Burdock Ponds

Burdock ponds: This slide has the different pond types labeled.

From Figure 6.1-2 Proposed Alluvial Monitor Wells Burdock Land Application Area DENR GW Discharge Permit App

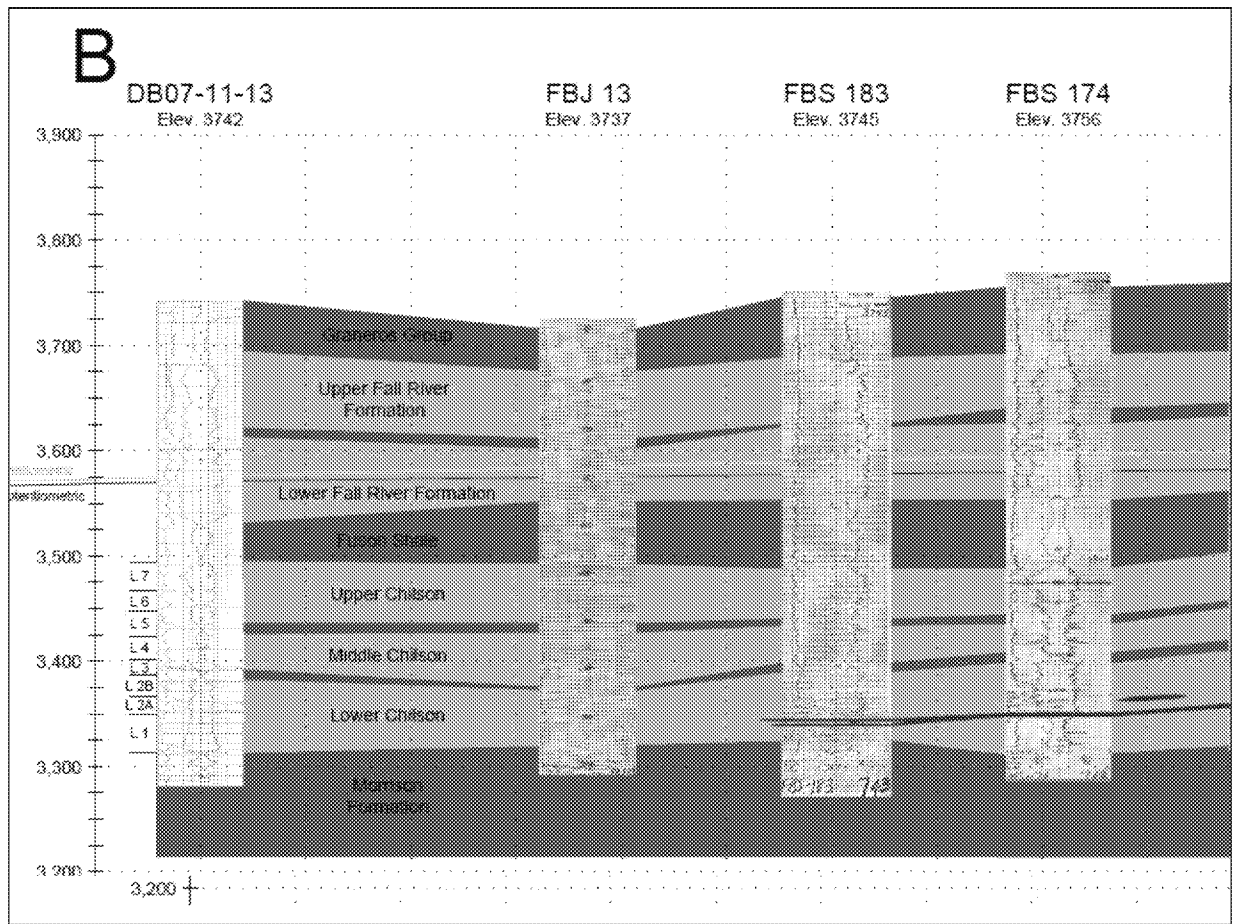
If you click on the pond map and move it to overlay Section 2, it is transparent while you are moving it. This allows you to see how the ponds line up with the outlines I have drawn. One pond is entirely in the alluvium and the other lies partly in the alluvium.

Portion of cross-section B – B' approximately cross-dip from Burdock Ponds. There is more to the right off the slide.

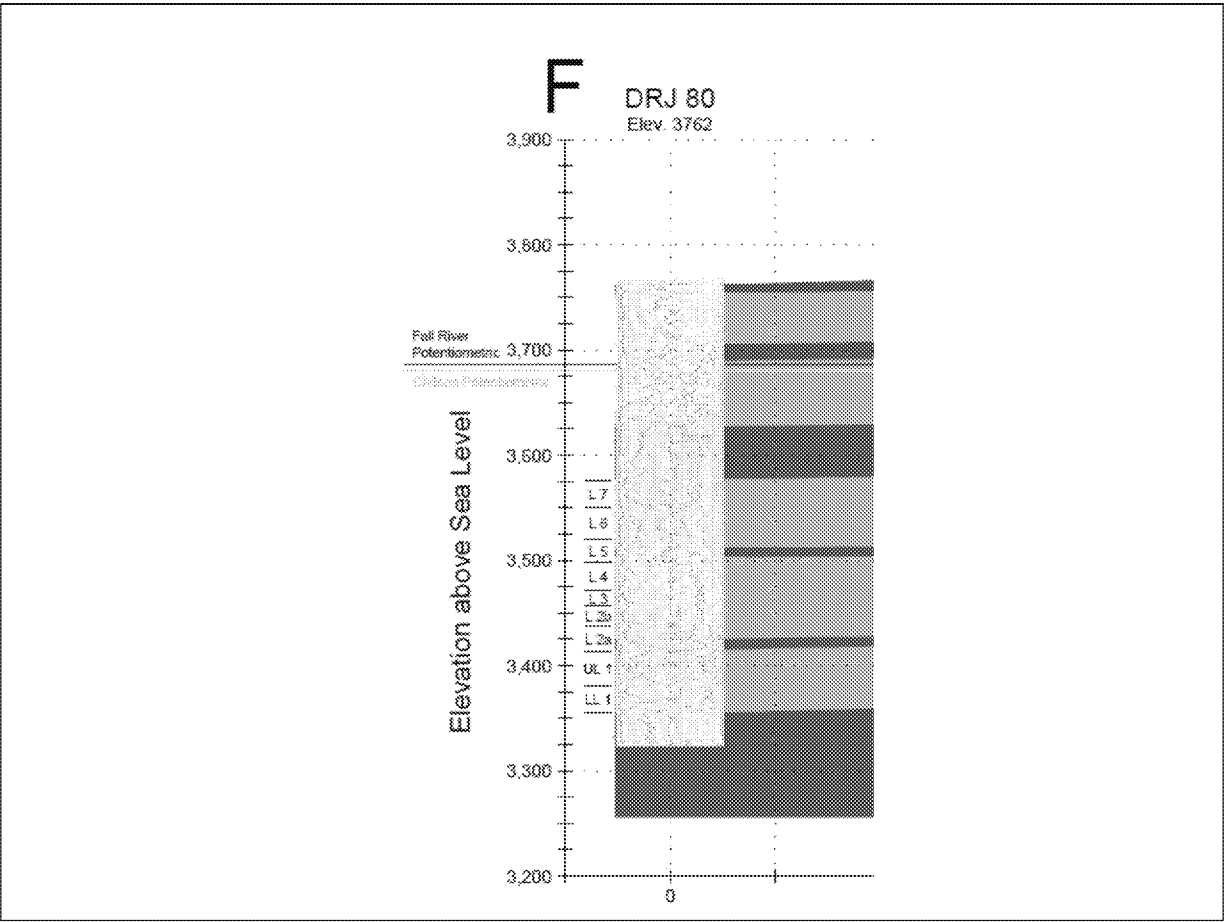
DRJ 80 has less than 10 feet of shale.

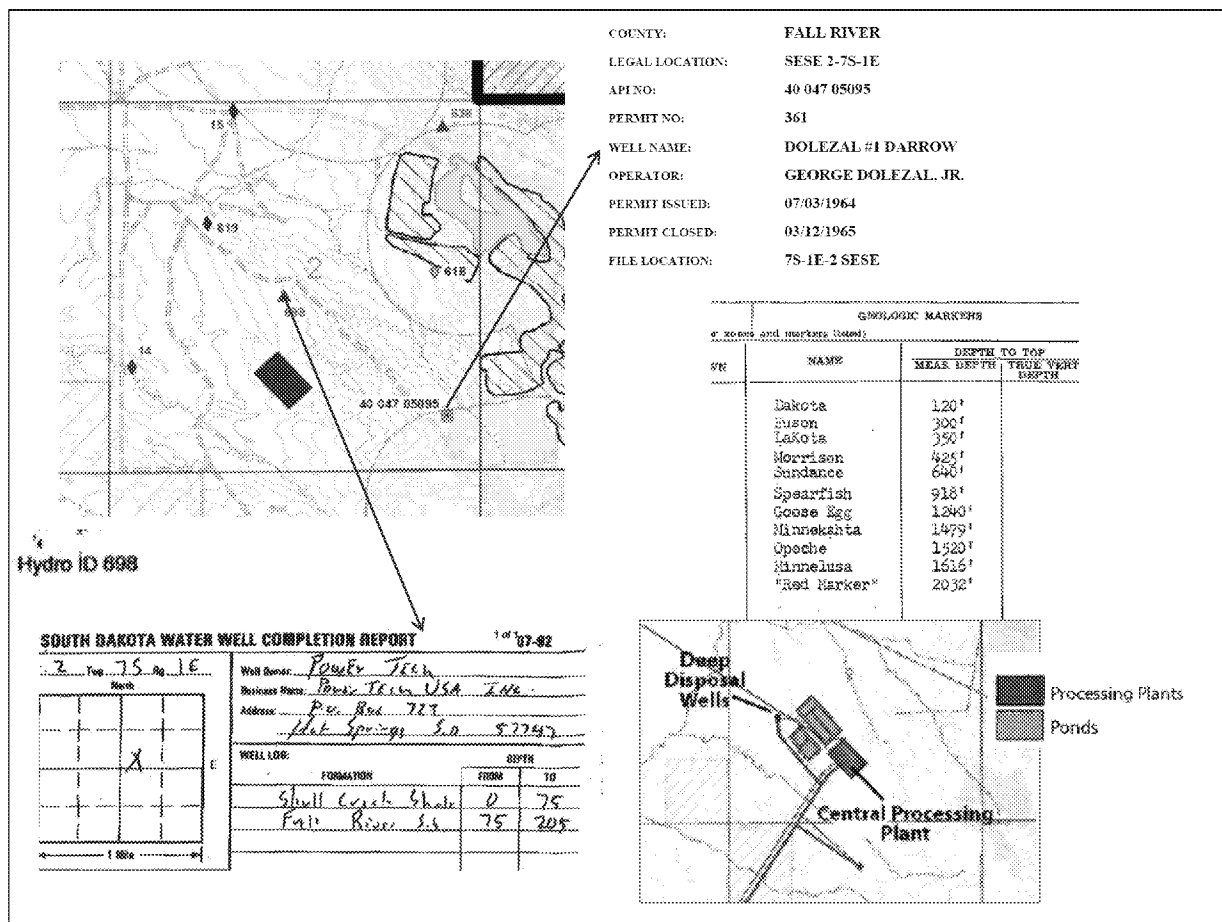
Well log from Dolezal #1 Darrow shows top of Fall River (called Dakota) at 120 feet deep. But Powertech's well completion report for the monitoring well #698 shows 75 feet of Skull Creek (part of the Graneros Group of shales). The logs for wells 14, 619 and 15 are not in the DENR well database. The Linch well is the only well that shows up in the DENR well database.

The Linch well (info from the DENR well database) Well #698 is probably closer to the ponds.

Figure 4.2: Dewey-Burdock Drill Hole Map from the Class III Permit Application
Burdock Area

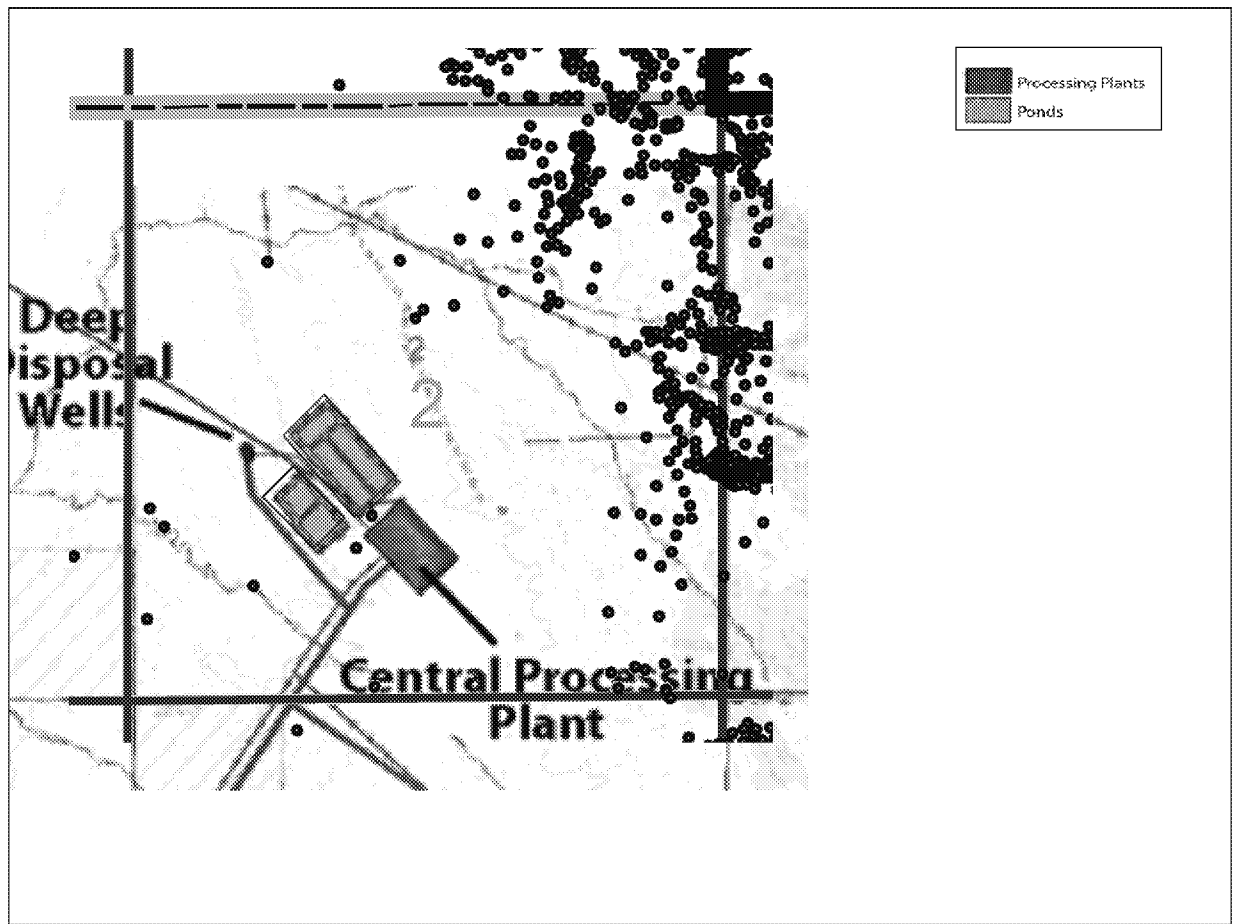
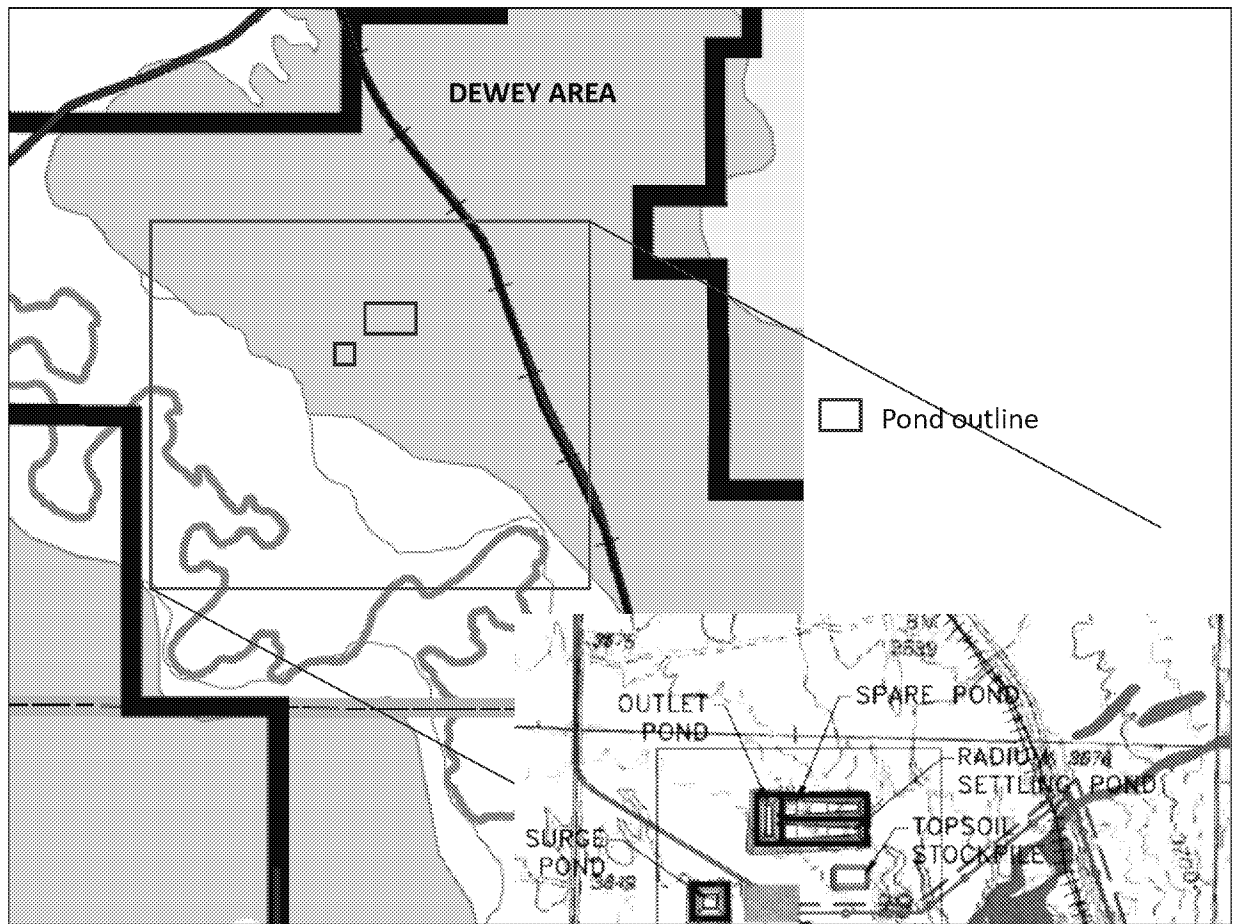
The Burdock ponds do not lie over any exploratory drill holes.

Dewey Area Figure 6.3 Site Surface Geology Class III Permit App The Dewey ponds lie on top of at least 400 feet of Graneros Group shale (Belle Fourche, Mowry and Skull Creek Shales).

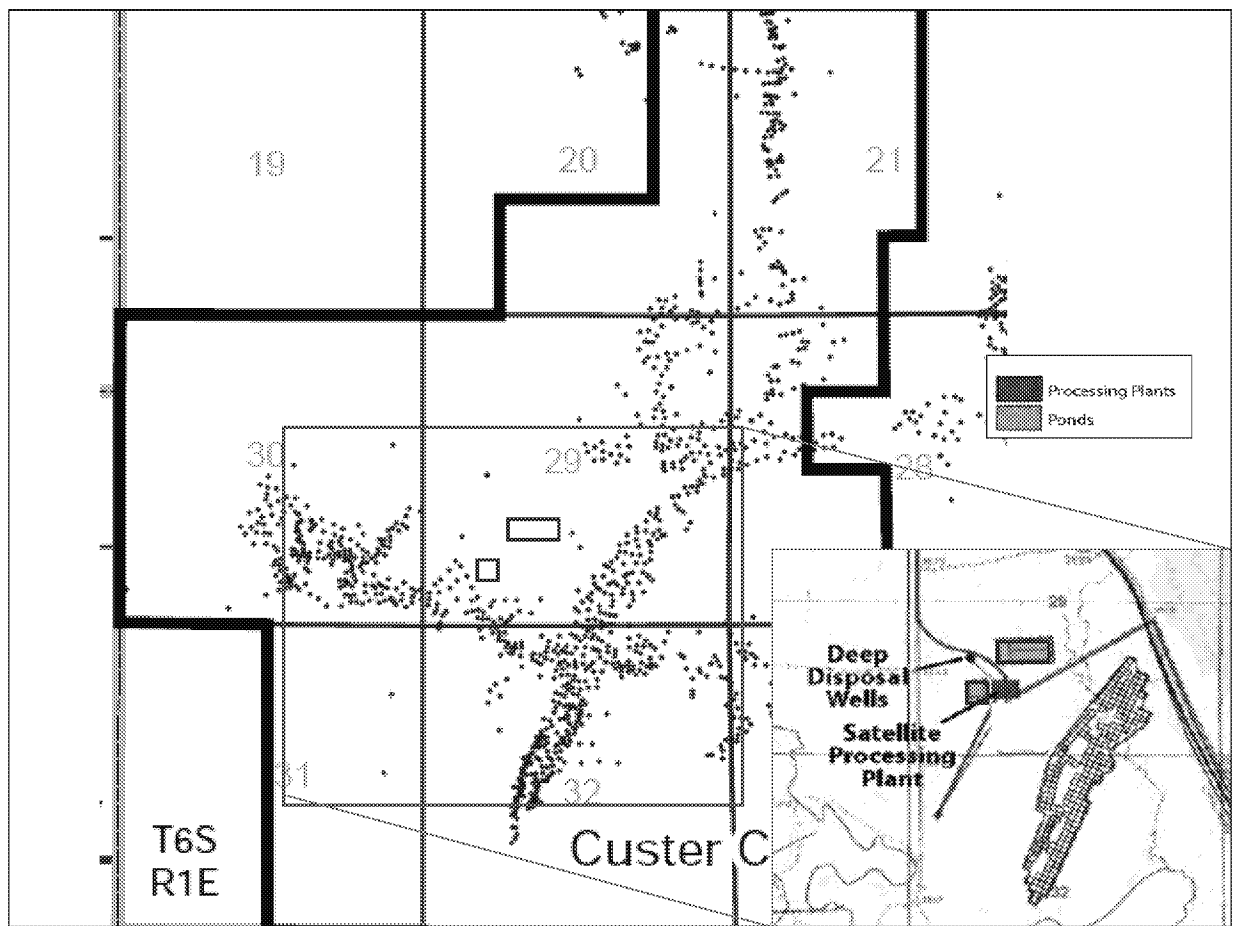
The Dewey ponds do not lie over any exploratory drill holes.
